Access Compliance Report

Public Rights-of-Way

(Pedestrian Signals)

Intersection ID: N/A	Main Street:	Cross Street: N/A	Location: N/A
ADA ID: 5DC81877CD54	Signal Type: One Push Button-Non APS	Overall Compliance: No	Severity Score: BTN 1: N/A BTN 2: N/A No BTN: N/A
Codes/Mitigation Info/Possible Solution		Field Measurements/Component Compliance

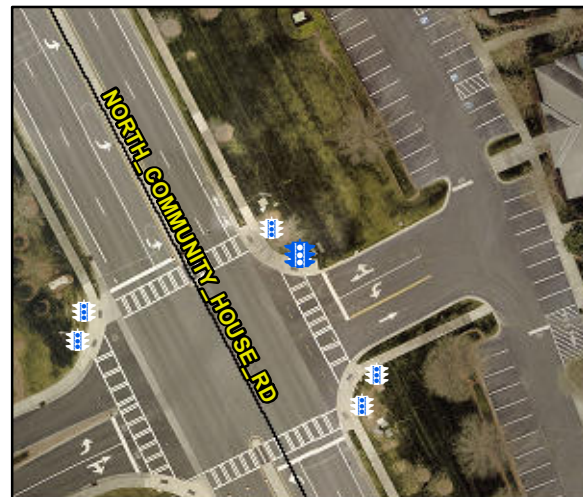
PROW/ADA: TMUTCD 4e.08, R404.2, R406.2

Possible Solutions: Replace Signal Push Button With APS Button on New Post. Remove & Relocate Sign.
